**BEFORE THE BOARD OF PATENT APPEALS
AND INTERFERENCES**

Application Number: 09/848,583
Filing Date: May 03, 2001
Appellant(s): MATTHES ET AL.

EXAMINER'S ANSWER

Fig.1

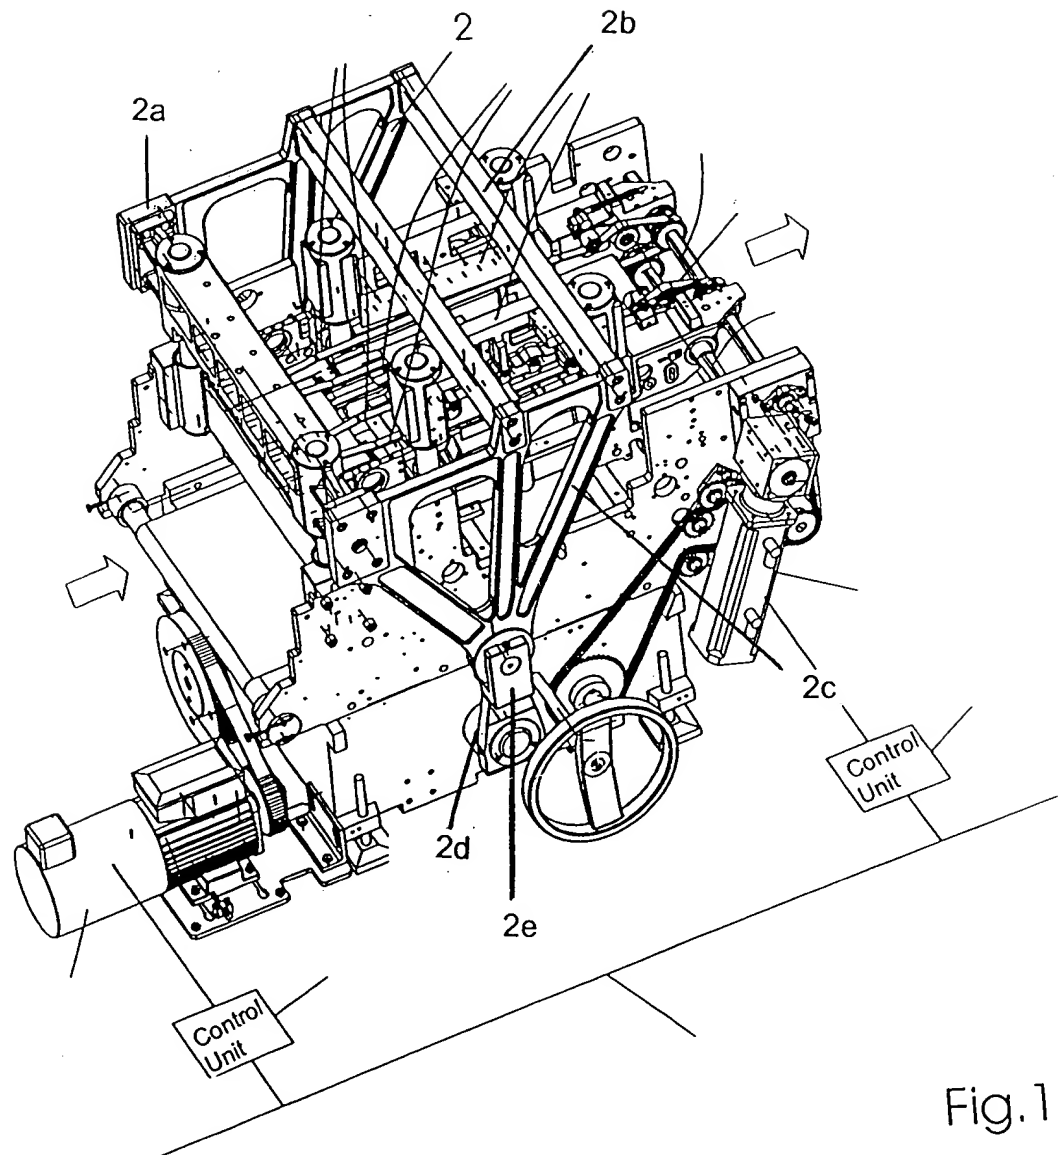
In regards to claim 1, it is unclear how the lifting device 2 uses the vertical, non-harmonic oscillatory motion to press knives 3 against the knife 13. It is uncertain if the whole lifting mechanism 2 moves up and down to move the knives 3 towards knife 13 or if the lifting mechanism pivots about the screw (Figure 2) and during this pivot the blades are dropped down to cut the work piece. Also, it is not clear what type of cutting is taking place. It is uncertain if knife 13 is a stationary blade to create a shearing cut with knives 3 or blade 13 acts as an anvil and knives 3 perform a punching/stamping cut. The functional language provided is not supported with any structure shown in the Figures or any structural language explaining how the lift mechanism moves knives 3 towards knife 13 to create the cutting action. It is unclear how a vertical, non-harmonic oscillatory motion is created and how the knife-lifting device (2 and 2a-2e) can move when it is fixed to the transmission at 2d.

Appellants contend that the use of the motor (1) with the belt (23), pulley (21), and transmission (22) achieves vertical, non-harmonic oscillatory motion of the knife-lifting device (2). The examiner strongly disagrees. Using Figure 1 on page 7 of this examiner's answer (and the added reference numbers 2a-2e), the knife-lifting device is considered to include all of the portions so labeled (All other reference numbers have been removed for clarity). Appellants have not provided support or a detailed

description of the knife-lifting device. As items 2 and 2a-2e appear, from the Figure, to be one piece or bolted together, it can only be interpreted by one of ordinary skill in the art that the knife-lifting device refers to this entire object, in that appellants' reference number 2 must reference all of the object including reference numerals 2a-2e added in the attached figure by the examiner. It cannot be determined how the transmission moves the knife-lifting device in a vertical, non-harmonic oscillatory motion. It is not supported by the specification and it is not shown in the Figures how the transmission and the knife-lifting device interact with one another to create the motion. In addition, it is unclear how the knife-lifting device (2 and 2a-2e) moves in a vertical direction. The knife-lifting device is connected to the transmission at 2d but in order for the knife-lifting device to be able to move in a vertical motion relative to the transmission there would have to be structure allowing 2d to move vertically within the transmission's casing. The knife-lifting device appears to be permanently fixed to the transmission at 2d, thereby restricting any movement at all. In order for the knife-lifting device to obtain vertical, non-harmonic oscillatory motion, the knife-lifting device (2 and 2a-2e) must somehow move, as a whole, vertically, in relation to the transmission.

Appellants also contend that one of ordinary skill in the art would easily understand from the drawings and the disclosure of the invention of the instant application how the lifting device (2) uses the vertical, non-harmonic oscillatory motion to press knives (3) against the knife (13). This is incorrect. The lack of description prevents clear understanding of the claimed and disclosed invention by one of ordinary skill in the art. For example, it is unclear how the motion can be considered non-

harmonic. A non-harmonic motion would be, in this case, a non-continuous vertical motion. It is unclear how the transmission would allow the knife-lifting device to be a non-continuous motion. Also, one of ordinary skill in the art would not have the ability to know how this apparatus creates a non-harmonic motion without undue experimentation. In addition, it is unclear how the knife-lifting device (2 and 2a-2e) moves in the vertical, non-harmonic oscillatory motion relative to the transmission when part of the knife-lifting device is fixed to the transmission (2d).
